21 February 2020

Addendum 2

Renovations to 210 Turner Street
Carteret County Administration Office
Beaufort, NC

A-1R

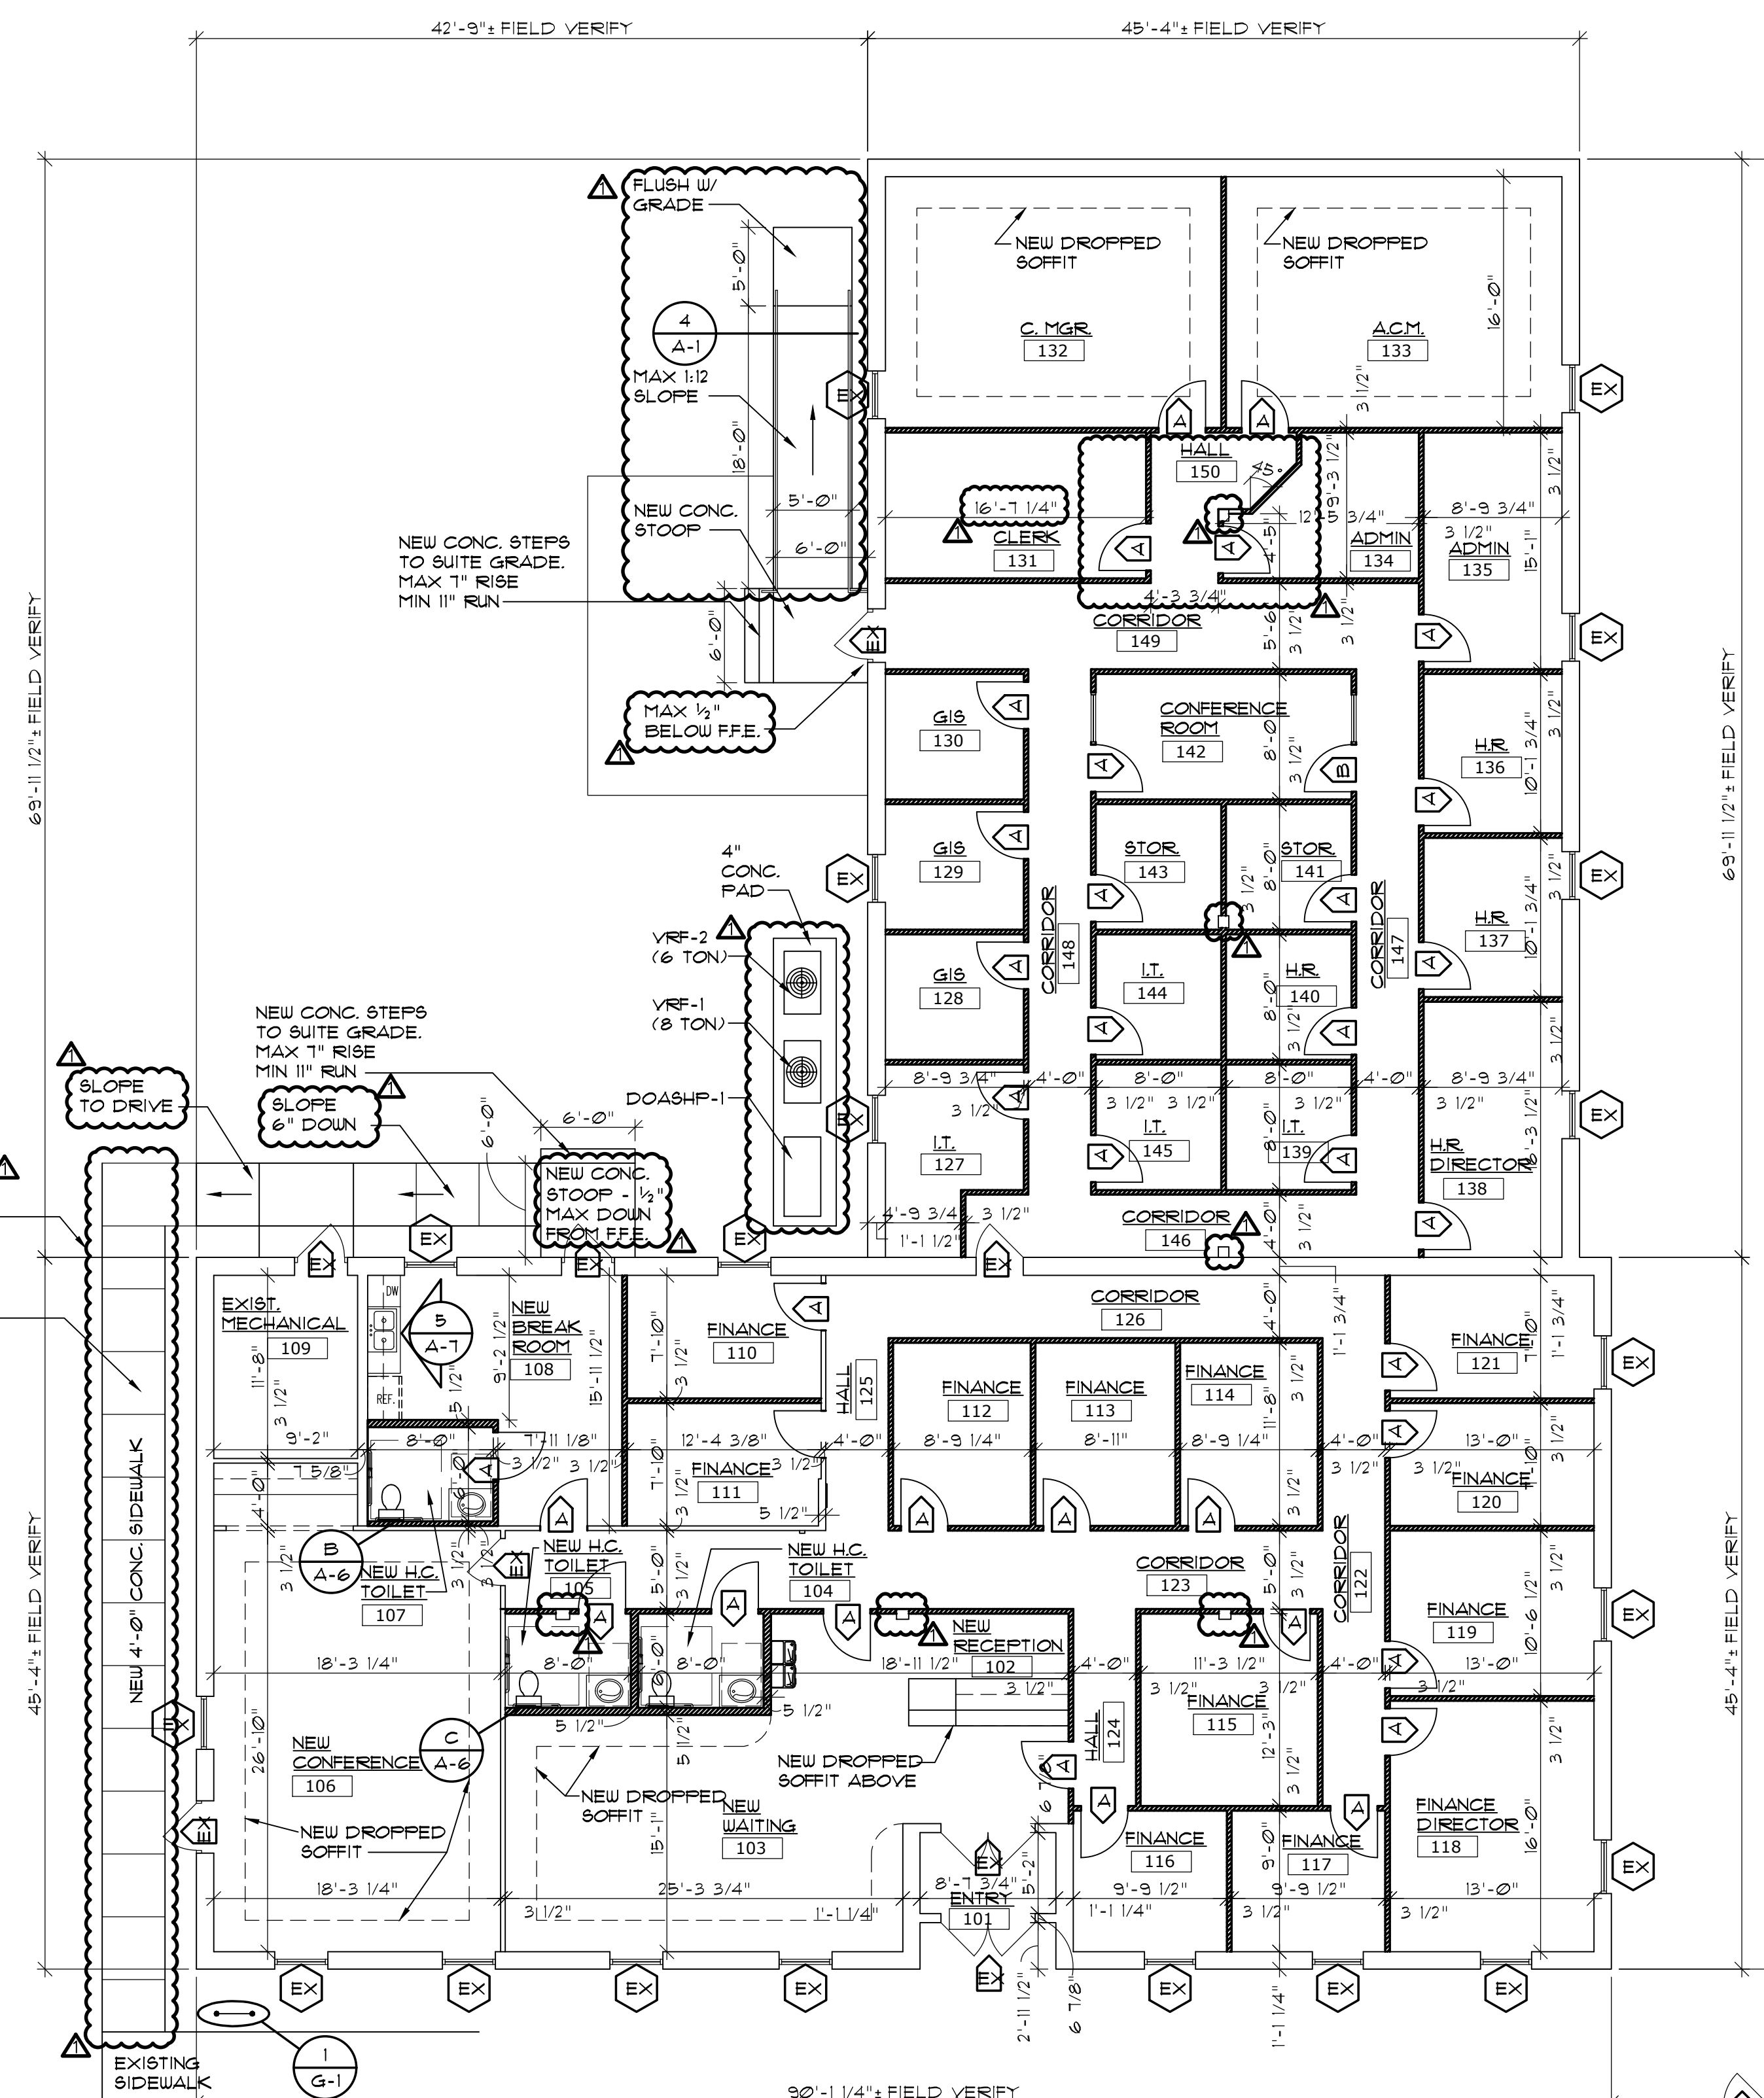
- Bid date is revised to March 9, 2020, at 3:00PM in the County Commissioners Board Room.
- See attached A-1R showing revised area.
- Clarification; Contractor to rebuild soffit area as required where carport is being removed.
